Valentin Residence

ADDRESS ESA
RECOMMENDATIONS
TO CRITICAL AREAS
REPORT
June 8th, 2018

File No. CAO17-003 – Valentin Critical Areas
Determination

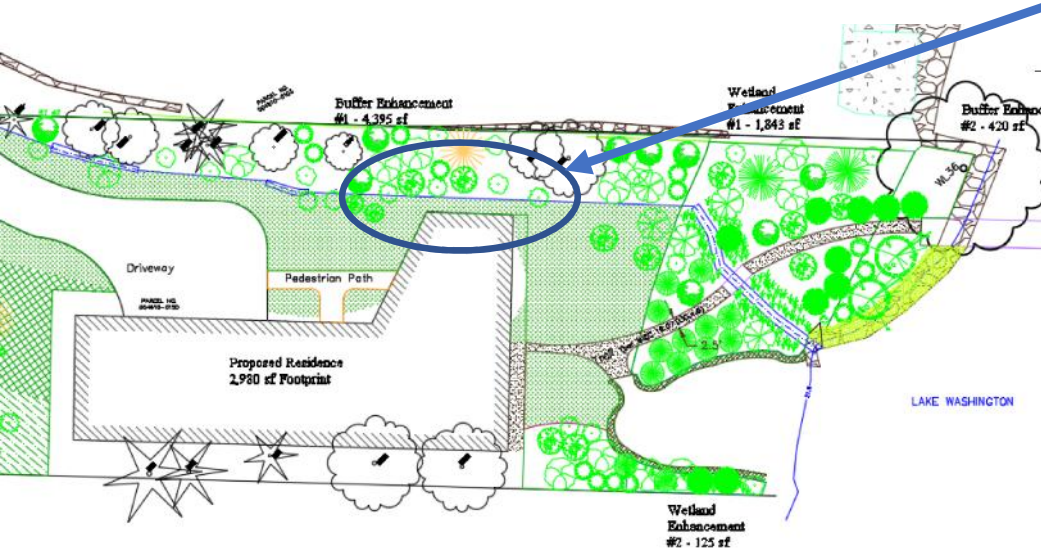
ESA Recommendation #8: The “buffer enhancement and mitigation” area shown on the Impacts and Buffer Mitigation sheet includes non-buffer area (southwest corner of parcel). There are no issues with enhancing this area; however, it should not be included in the total buffer enhancement area calculation.

Removed non-buffer area calculations.

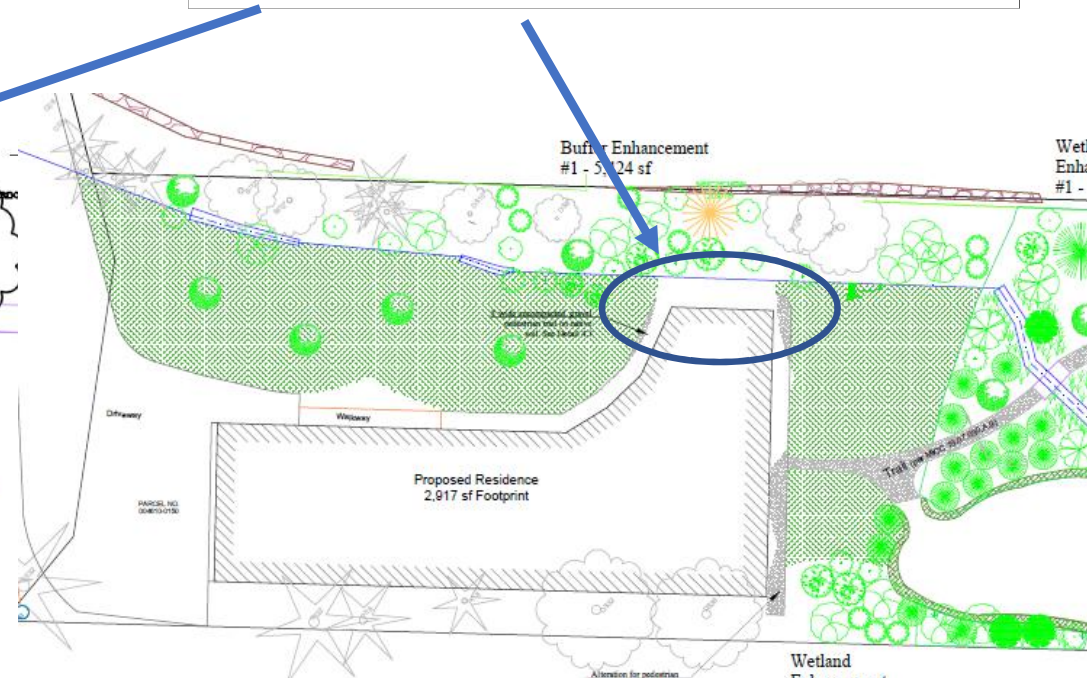
ESA Recommendation #9: The three-foot proposed reduced buffer from the piped watercourse does not allow for future daylighting of the stream and therefore results in net loss of watercourse and buffer functions. Please proposed a larger buffer that will result in no net loss; please increase the buffer width and provide documentation indicating that the revised width will allow for future daylighting of the watercourse.

As discussed with the City, increased setback to 5 feet to allow for future daylighting (not proposed or part of this project).

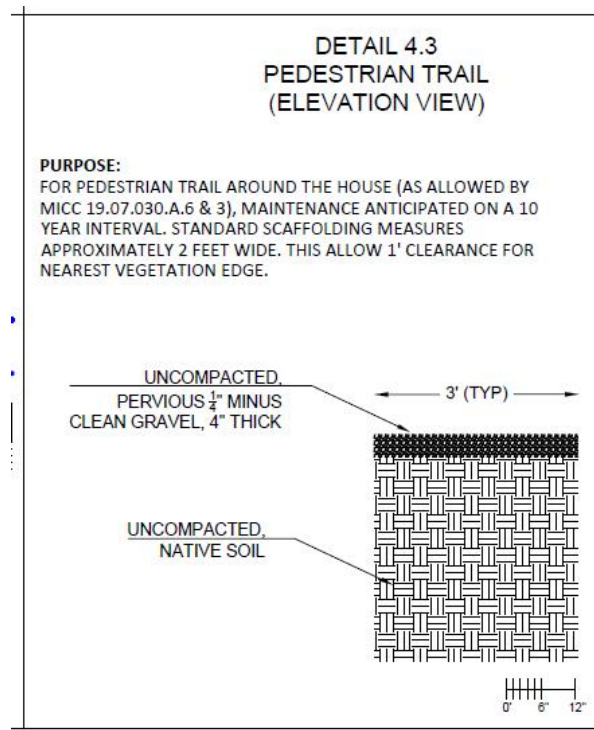
ESA Recommendation #10: (Previous Review Comment) Detailed plans should be provided for the proposed trail and bridge to document materials, construction methods, and mitigation to ensure consistency with MICC Chapter 19.07 allowances, and to adequately compensate for wetland, stream, and buffer impacts. The updated Critical Areas Study and Mitigation Plan sheets do not discuss the proposed trail and bridge that provide access to the dock or detail the construction methods or proposed materials. Per MICC 19.07.030(A)(9), trails should be made of pervious materials, unless the code official determines impervious materials are necessary to ensure user safety. Please provide this information.

Details have been added to the mitigation plan. This is our fault, it was an oversight in the previous submission.
